Executive Director's Recommendation

Commission Meeting: July 9, 2020

| PROJECT Lincoln Memorial Rehabilitation 2 Lincoln Memorial Circle, NW Washington, DC | NCPC FILE NUMBER 7866 |
| REVIEW AUTHORITY Federal Projects in the District per 40 U.S.C. § 8722(b)(1) and (d) | APPLICANT'S REQUEST Approval of preliminary and final building plans |

EXHIBIT LEVEL PLAN

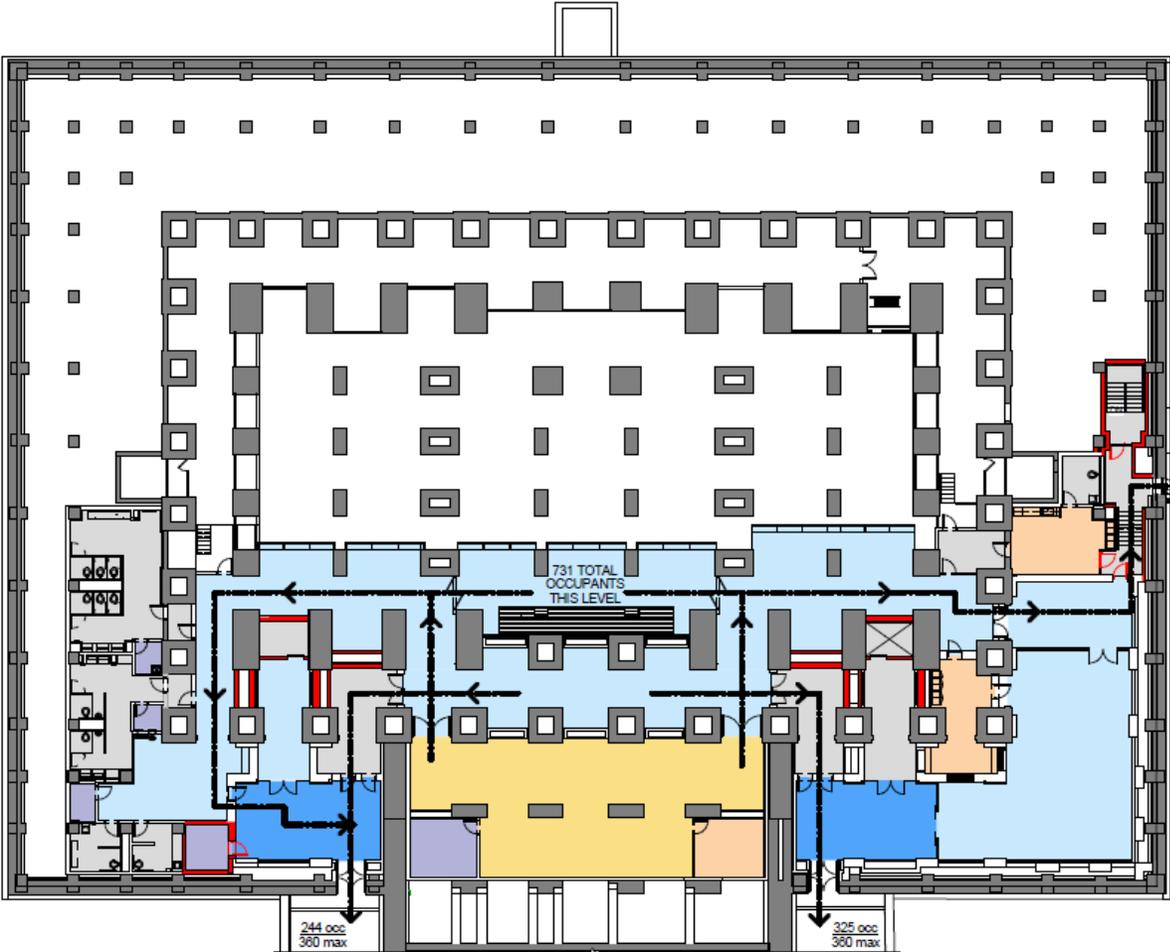
The openings to the Undercroft require enlargement in order to meet the egress requirements of the occupied space. The width of the existing openings in the east facade are being enlarged. To address the number of exits required for the assigned occupant load, a third exit will be added at the existing vent location in the north facade. This opening will not be a main entrance and serve as exit only in the event of an emergency.

ENLARGED ELEVATION AND PLAN - SOUTH EAST GATES - OPTION B (BRONZE CLAD LINTEL)

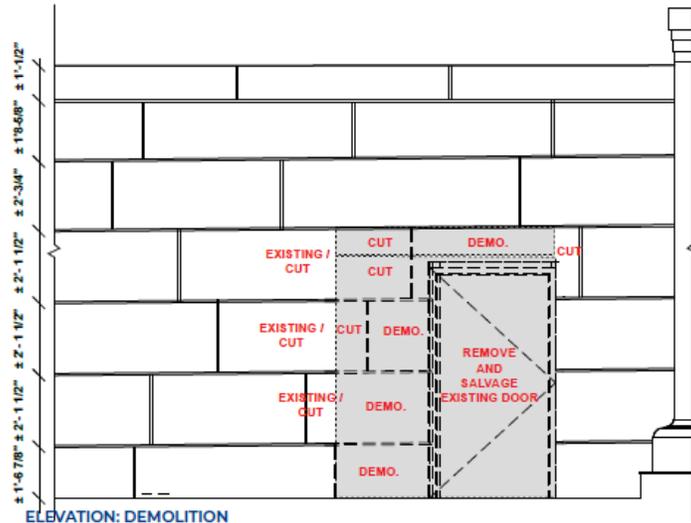
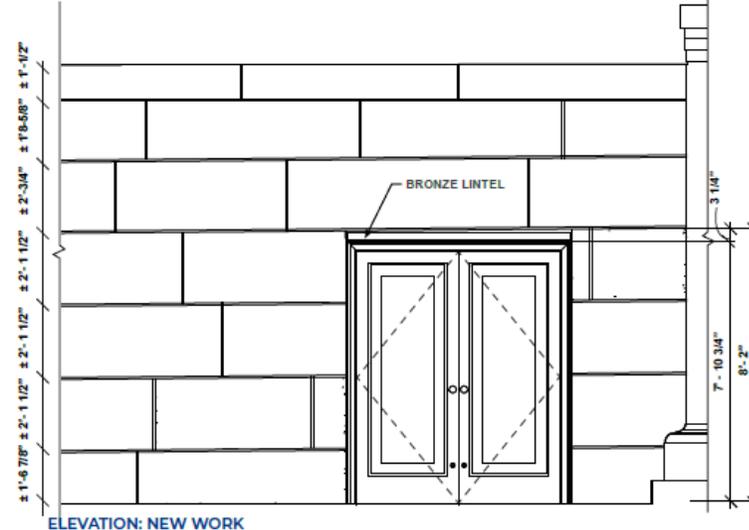
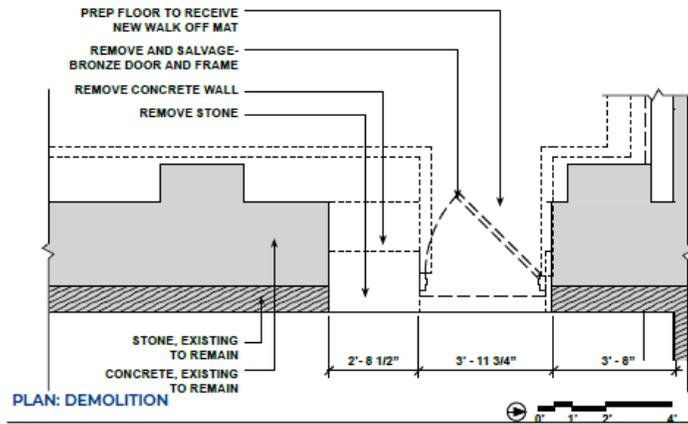
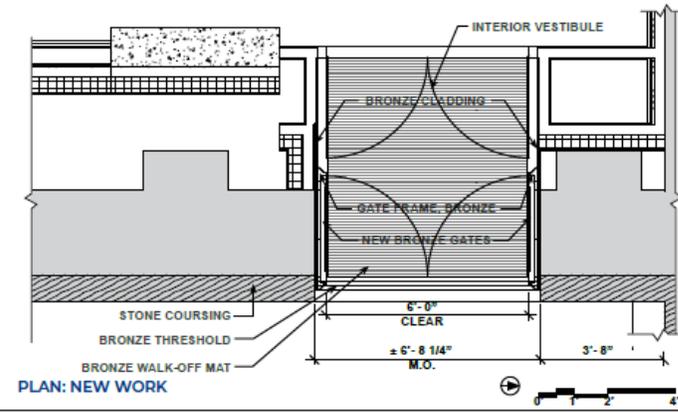
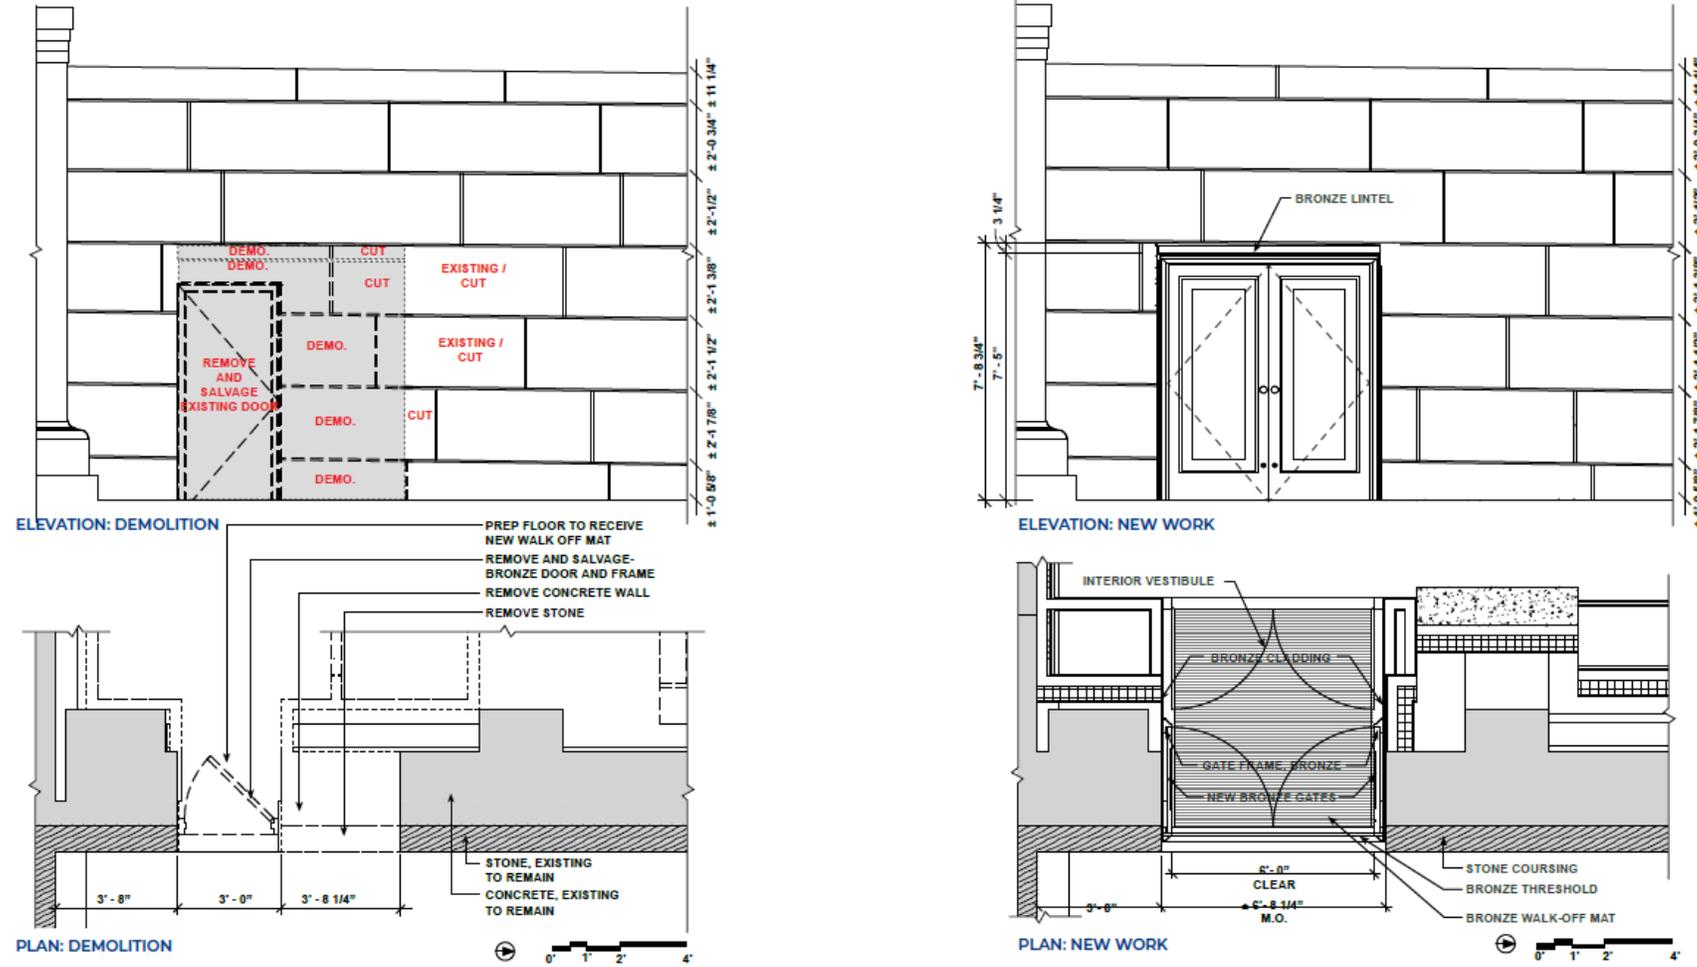
The Commission members recommended the project team's preferred option for detailing the enlargement of the doorways on the east-facing walls of the memorial's base; this option, with a visible bronze lintel as part of the enlarged doorways, is tectonically straightforward and minimizes the impact on the memorial's walls by reducing the number of existing granite stones to be cut or removed.

Approves the applicant's preliminary and final building plans to increase the existing door widths to 72 inches at the ground terrace level of the Lincoln Memorial's east elevation, with new bronze lintels, to allow increased accessibility and functionality to the rehabilitated and expanded visitor services areas located in the memorial undercroft, and for the new egress door on the north side of the Memorial.
